Docket No.: STN 50-483

Subject: Revision to Callaway Plant, Unit 1 Quality Assurance Program

17 QUALITY ASSURANCE

17.2 Organization for the QA Program

Figure 17.1 UNION ELECTRIC ORGANIZATION

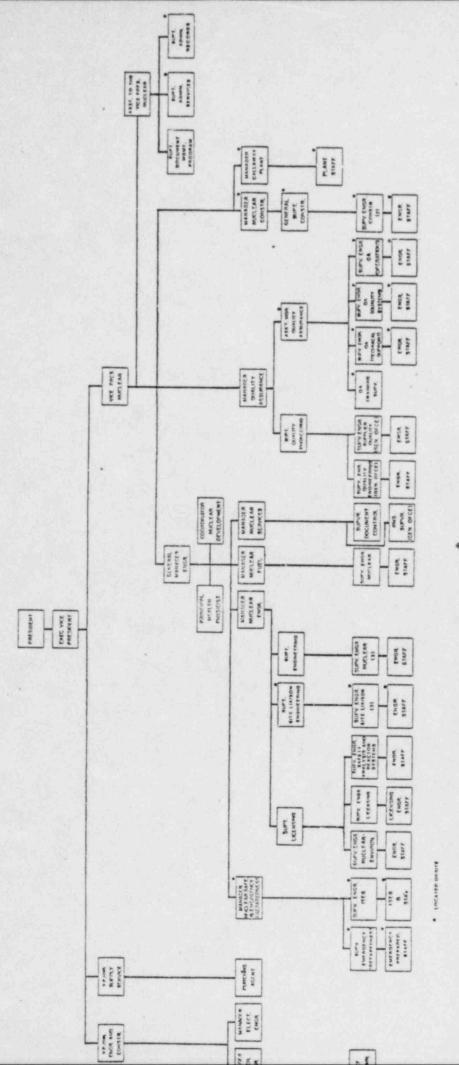
The structure of the organization responsible for the operation of Callaway and for the establishment and execution of the operations phase QA program was revised by the applicant in FSAR Revision 8. Figure 17.1 of this supplement reflects this revised organization and supersedes Figure 17.1 in SER Supplement 3.

Along with other duties, the Assistant to the Vice President, Nuclear, is now responsible for the Records Management Program for Callaway. The Superintendents of both the Nuclear Document Management Program and the Records Administration report to him.

The organization under the Manager, Quality Assurance, is now as follows: The Superintendent, Quality Engineering, is located at the General Office and directs the Supervising Engineer, Quality Engineering, and the Supervising Engineer, Supplier Quality. The Supervising Engineer, Quality Engineering, is responsible for QA's engineering activities at the General Office and audit and surveillance of General Office activities. The Supervising Engineer, Supplier Quality, has primary duties involving the audit and surveillance of and supplier quality activities. The Assistant Manager, Quality Assurance, is located at the Callaway Plant. He directs the QA Training Supervisor, the Supervising Engineer, QA (Technical Support); the Supervising Engineer, QA (Quality Systems); and the Supervising Engineer, QA (Operations); who are located at the Callaway Plant. The QA Training Supervisor is responsible for general QA indoctrination and training for the nuclear functions. The Supervising Engineers are responsible for ensuring the implementation of the Operating Quality Assurance Program at the Callaway Plant. The Manager, Quality Assurance; the Assistant Manager, Quality Assurance; the Superintendent, Quality Engineering; and all supervising engineers in the QA Department are authorized to stop unsatisfactory work.

As discussed above, the applicant has incorporated a revised organization in FSAR Revision 8. The staff has reviewed this revised organization and concludes that it continues to give QA personnel sufficient independence from cost and schedule (when opposed to safety considerations), authority to effectively carry out the operations QA program, and access to management at a level necessary to perform their QA functions.
